Access Compliance Report

Public Rights-of-Way

(Curb Ramps)

Intersection ID: 10903	Main Street: TIPPERARY_PL	Cross Street: VINETTA_CT	Location:	N
ADA ID: 3C42E3059691	Ramp Type: Para	Initial Pass/Fail: Fail	Overall Compliance: No	Severity Score: 1.25
Codes/Mitigation Info/Possible Solution		Field Measurements/Component Compliance

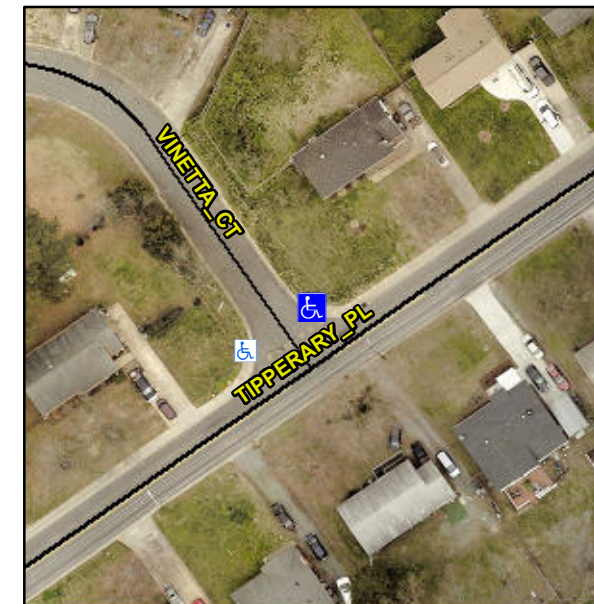
Surveyor Notes:

LT RP < 5%

PROW/ADA:

R304.5.3

Compliance	Description	Data	Compliance	Description	Data
N/A	Ramp Length LT (in)	26.5	N/A	Ramp Length RT (in)	27.0
Yes	Ramp Width LT (in)	48.0	Yes	Ramp Width RT (in)	48.0
Yes	Ramp Slope LT (%)	0.2	Yes	Ramp Slope RT (%)	7.6
Yes	Ramp XSlope LT (%)	0.9	No	Ramp XSlope RT (%)	3.1
N/A	Landing Length (in)	N/A	N/A	DWS Provided?	N/A
N/A	Landing Width (in)	N/A	N/A	DWS Contrast?	N/A
N/A	Landing Slope (%)	N/A	N/A	DWS Length (in)	N/A
N/A	Landing X Slope (%)	N/A	N/A	DWS Full Width?	N/A
N/A	Landing Curb? (Y/N)	N/A	N/A	DWS Offset (in)	N/A
N/A	Shared Landing?	N/A			
N/A	Gutter Ponding?	N/A	N/A	Gutter Slope (%)	N/A
N/A	Gutter Lip Ht (in)	1.0	N/A	Gutter X Slope (%)	N/A
N/A	Painted X Walk1?	No	N/A	Painted X Walk2?	N/A
	X Walk 1 Direction	To SW		X Walk 2 Direction	N/A
N/A	X Walk 1 Width (in)	N/A	N/A	X Walk 2 Width (in)	N/A
	X Walk 1 Slope (%)	1.5		X Walk 2 Slope (%)	N/A
	X Walk 1 X Slope (%)	2.5		X Walk 2 X Slope (%)	N/A
N/A	Ramp inside XWalk1?	N/A	N/A	Ramp inside XWalk2?	N/A

Possible Solutions:

Remove & Replace Entire Ramp.
